Proposed safety boom locations and flow simulation for proposed Bala hydro-electric generating station

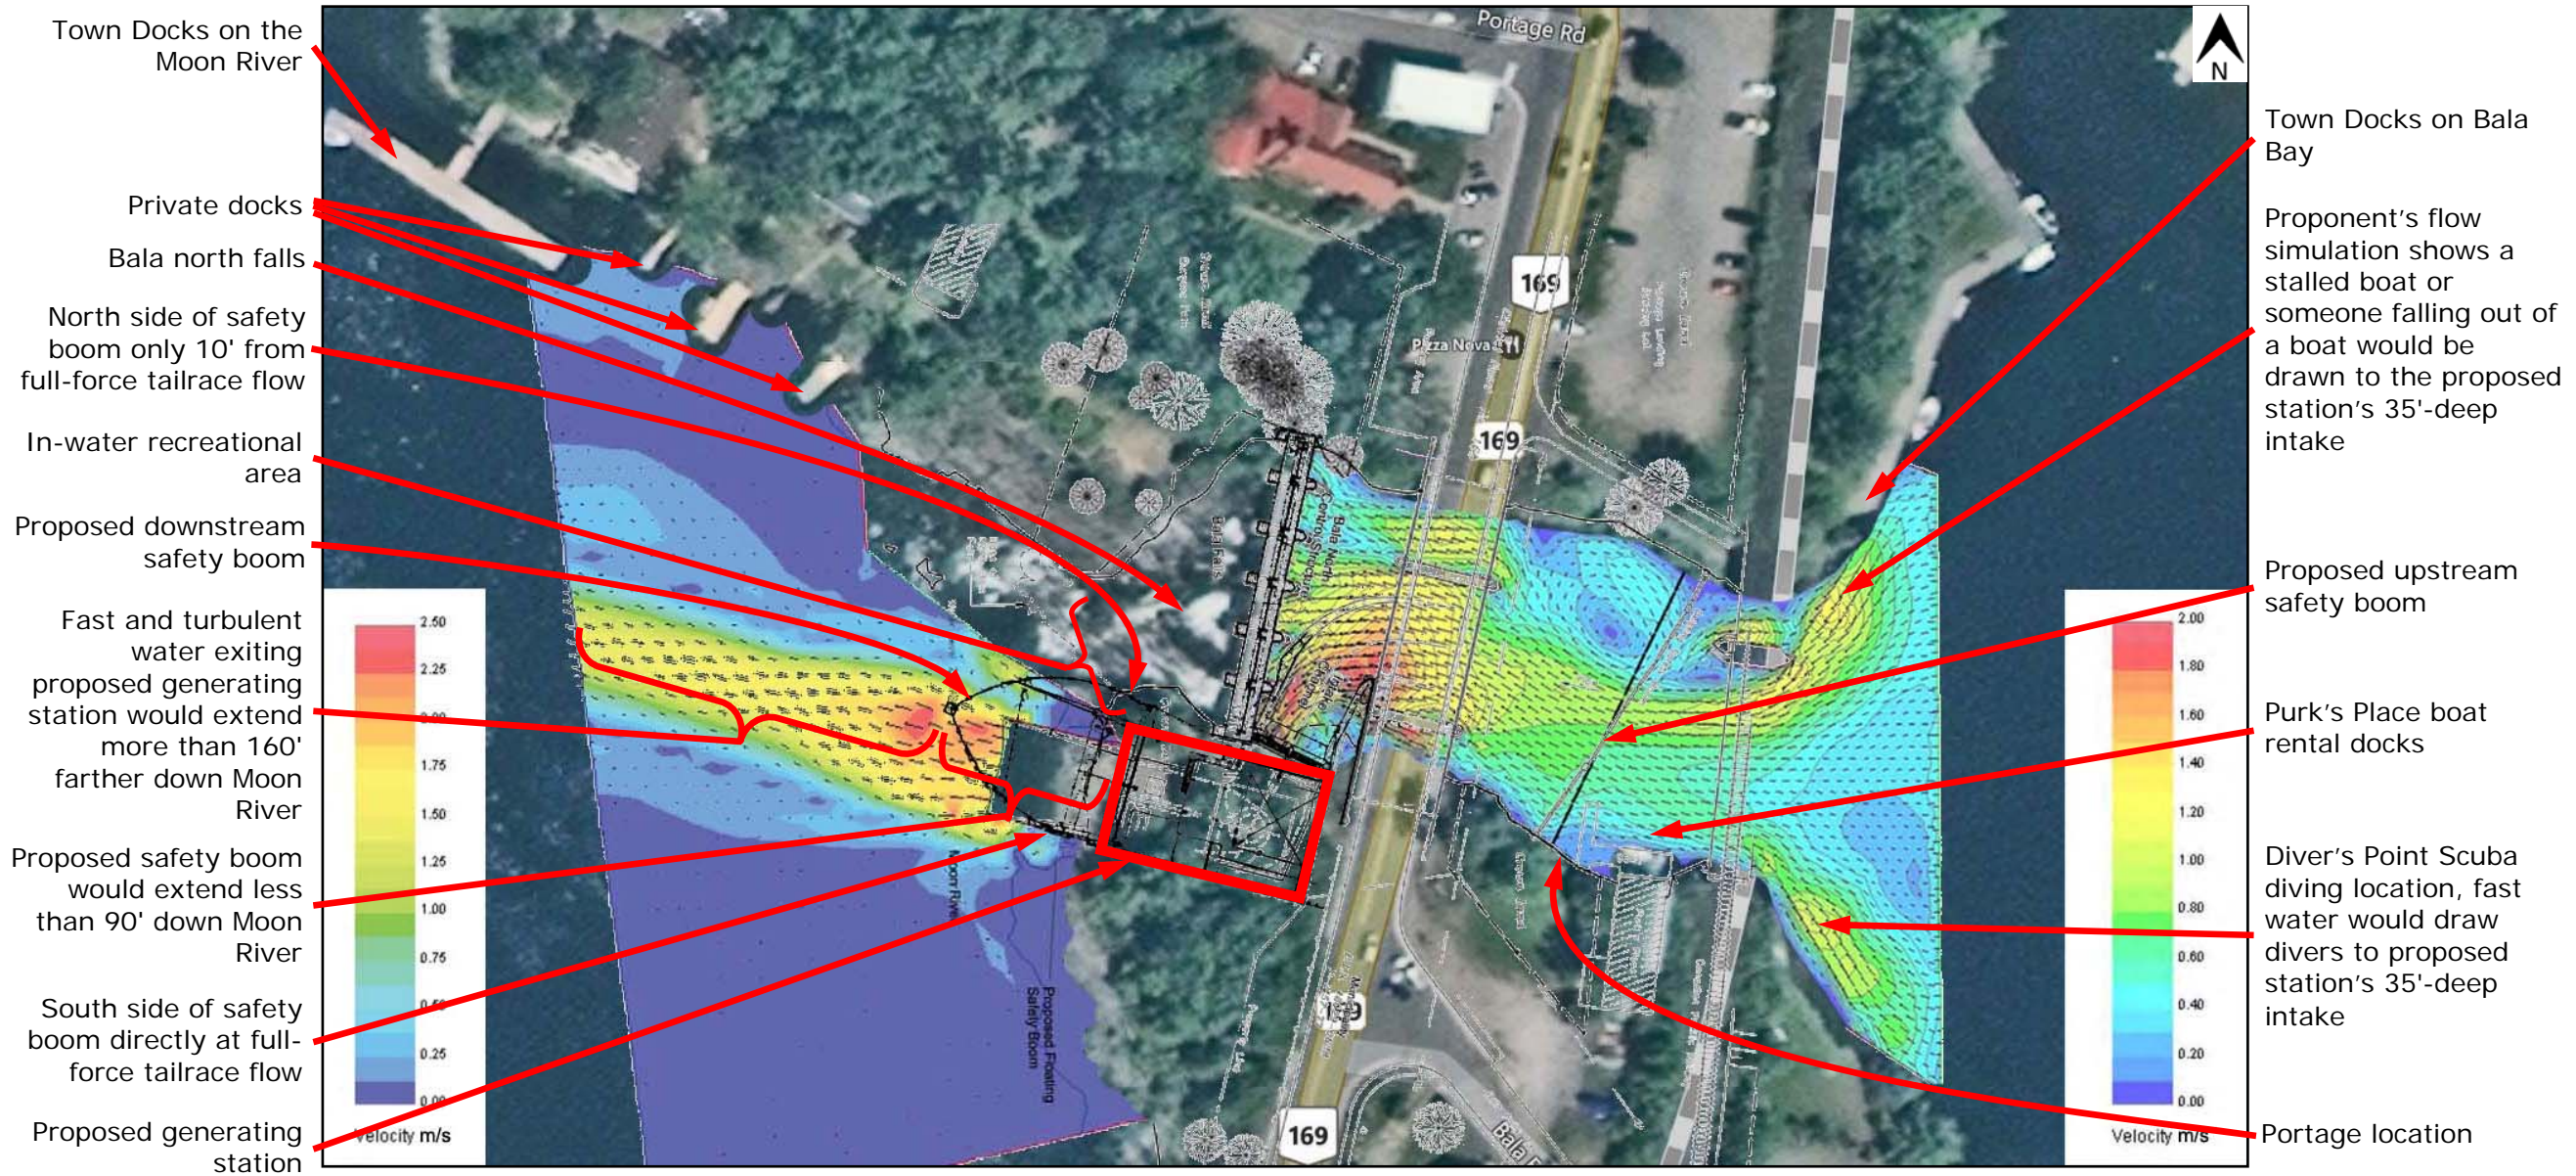
Turbulent water exiting the proposed generating station's tailrace would be:

- Just as **fast and dangerous outside of the proposed downstream safety boom as within it.**
- Only 10' from the in-water recreational area to the north, and directly adjacent to the public area to the south.
